SUBJECT: Forwards Rev 11 to FPLTQAR 1-76A, "Topical QA Rept."

Re: Turkey Point Units Nos. 3 and 4
Docket Nos. 50-250 and 50-251
St. Lucie Units 1 and 2
Docket Nos. 50-335 and 50-389
Topical Quality Assurance Report (FPLTOAR 1-76A)

Summary of changes to Revision 10 of the Florida Power and Light Topical Quality Assurance Report (FPLTQAR 1-76A)

ORGANIZATION OF DEPARTMENTS
AFFECTING QUALITY
FIGURE 1-1
APPENDIX A

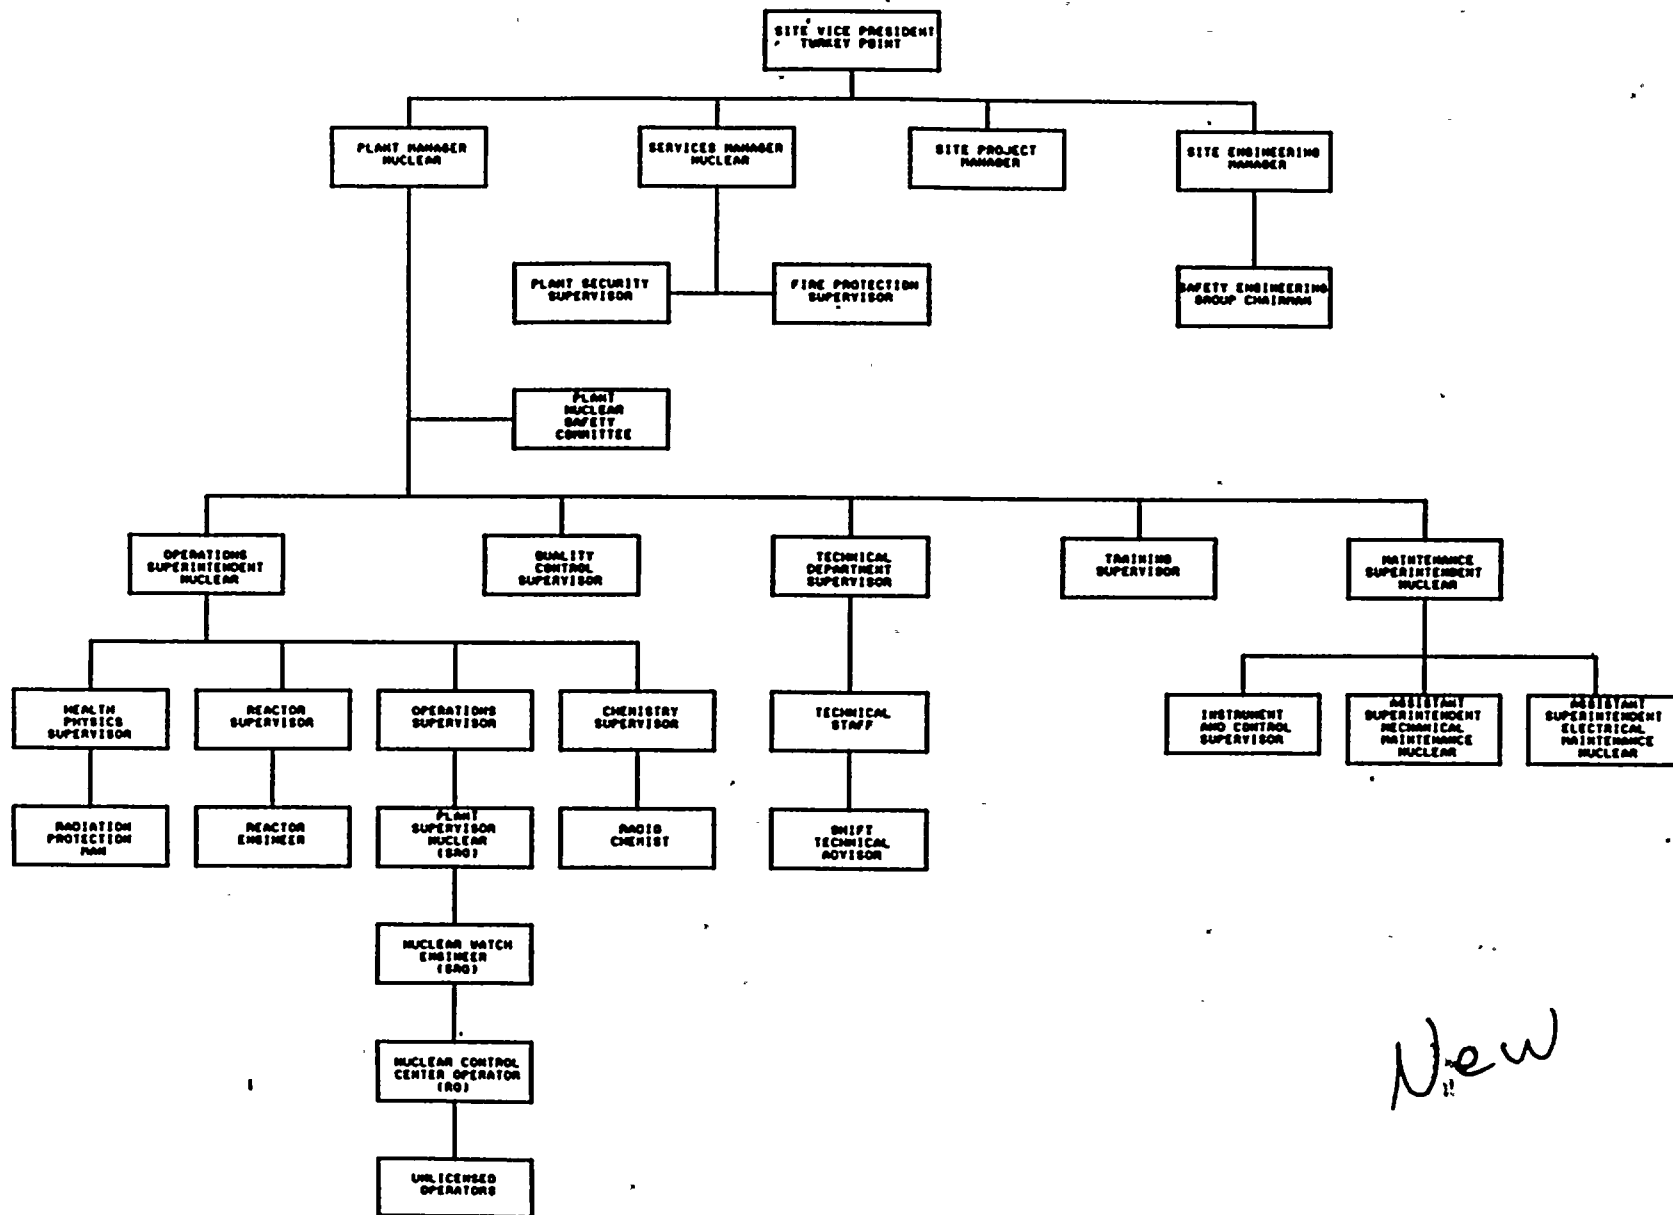
The three figures reflect the current organization changes of reporting requirements and position titles.
